APPENDIX 52A LETTER FROM TETRA TECH EBA – JULY 7, 2015

FILE: 704-V13203022

Subject: Hearing Order OH-001-2014
Trans Mountain Pipeline ULC (Trans Mountain)
Application for the Trans Mountain Expansion Project (Project)
Name of Intervenor: David M. Farmer
Response by Trans Mountain

Figure 2. Oxygen section along the Fraser Estuary in July 2000 (D. Masson, IOS, Sidney, Canada). The Pacific Ocean is to the left, the Strait of Georgia to the right, and the sill at Boundary Pass at $x = 180$ km.

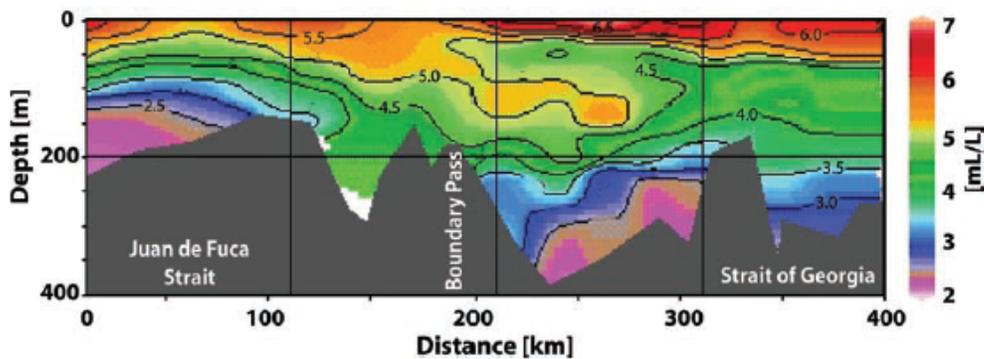
The authors of the Appendix, for instance in the Abstract, postulate that this frontal circulation feature is responsible for large amounts of mixing. It is difficult to square this with Figure 2 from the Appendix (shown below), which shows the oxygen distribution in a longitudinal section through the Salish Sea. A tongue of oxygen-rich water is evident northward (to the right of) Boundary Pass, at a depth of about 100 m, as if the surface waters

coming from Boundary Pass were bodily entrained into a mid-depth flow. Oxygen levels in this tongue of water are similar to surface oxygen levels in Boundary Pass, indicating that little mixing of these waters occurs as they enter the Strait of Georgia, since such mixing would change oxygen levels. The Appendix also reports that the amount of air entrained at the front could only increase the oxygen content of the water containing bubbles by 4.6×10^{-3} mL/L, or less than about 1/1000th of the oxygen level in the mid-depth tongue shown in Figure 2 of the Appendix with a value of about 5 mL/L. From these considerations, one can infer that the mechanism to transfer air bubbles generated at the water surface by wave breaking into the descending flow in Figure 5 is weak, and the appearance of the tongue is simply related to advection of surface waters in Boundary Pass, including the descent along the northern side of the sill as the flood tide enters the Strait of Georgia.

Figure 5. Flow over the sill at Boundary Pass during strong forcing on September 29, 2000. The colors show the acoustic backscatter intensity measured with an echo sounder and the black arrows indicate the current speed perpendicular to the sill crest. The aspect ratio is 1:1.

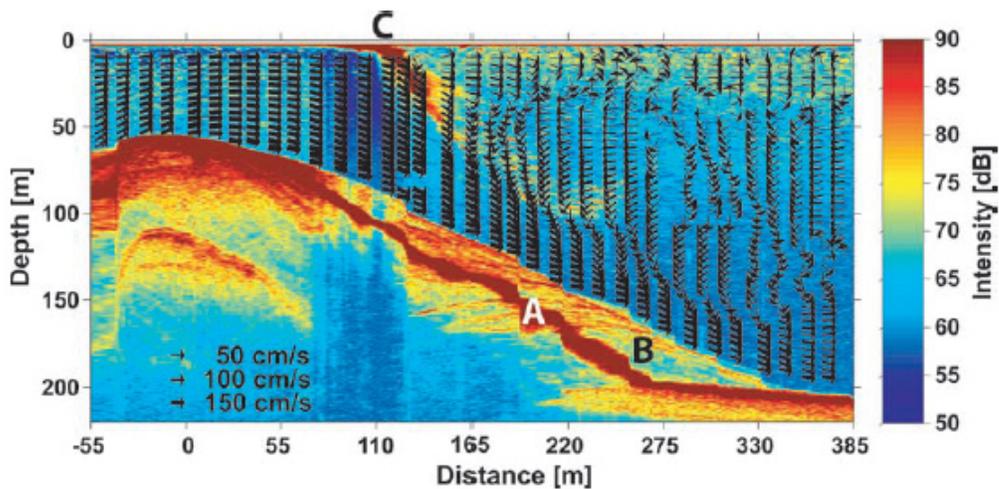
With respect to Figure 2 of the Evidence, there is the appearance of the lighter grey-shaded water sitting in place as a solid body, with the flooding tide plunging underneath it. It is understood that this sketch is based on observational data shown in Figure 5 of the Appendix (shown below), where one does indeed note that the strong flooding water are generally attached to the bottom on the lee side of the sill, and a deep, fast current characterizes the bottom 50-m or so of the water column. Currents above 100-m depth are much slower, and in fact, there is a large depth range over which they flow upstream, in an ebb direction. Currents in the top 40-m generally maintain a flood direction.

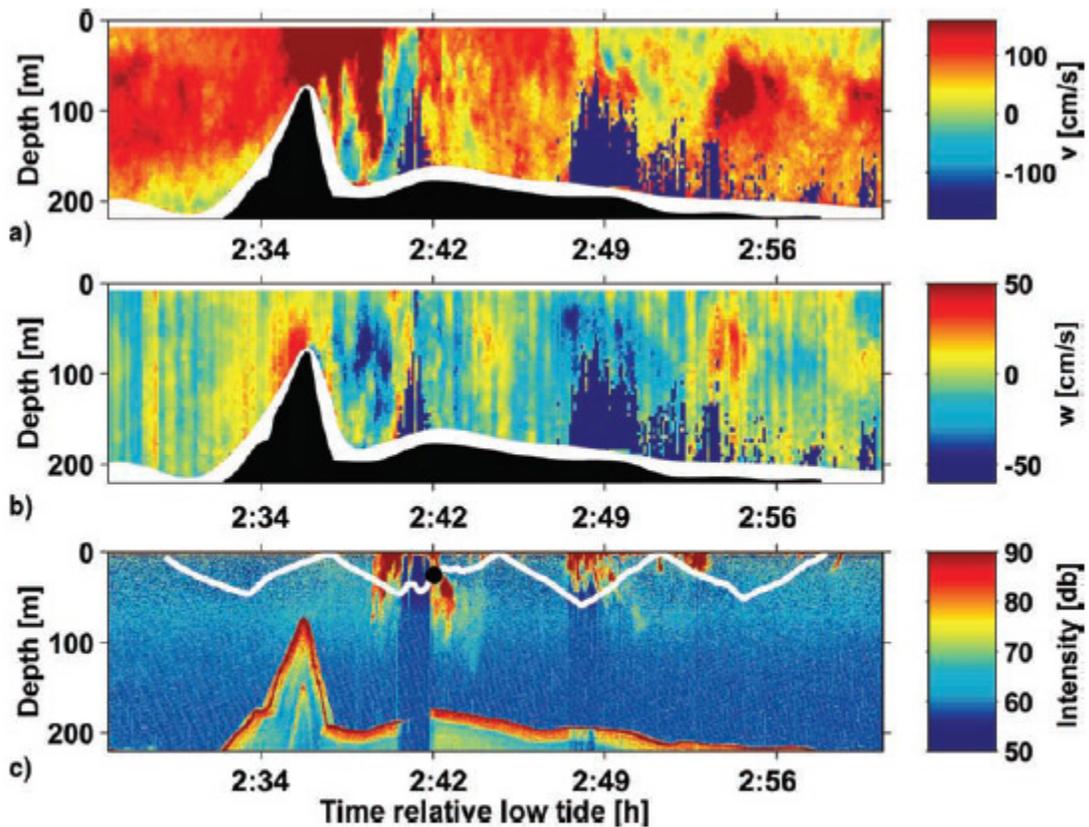
Furthermore, if one examines Figure 6 of Appendix A (shown below), one notes that in the top panel, showing the along-strait current, that there is no reversal of flow at the surface, in agreement with Figure 5. So, while some water may move downward, some carries onward at the surface. This observation argues against the concept of a conveyor belt-like system that carries all surface water down to depths of 50-100 m, as Figure 2 of the Evidence implies.
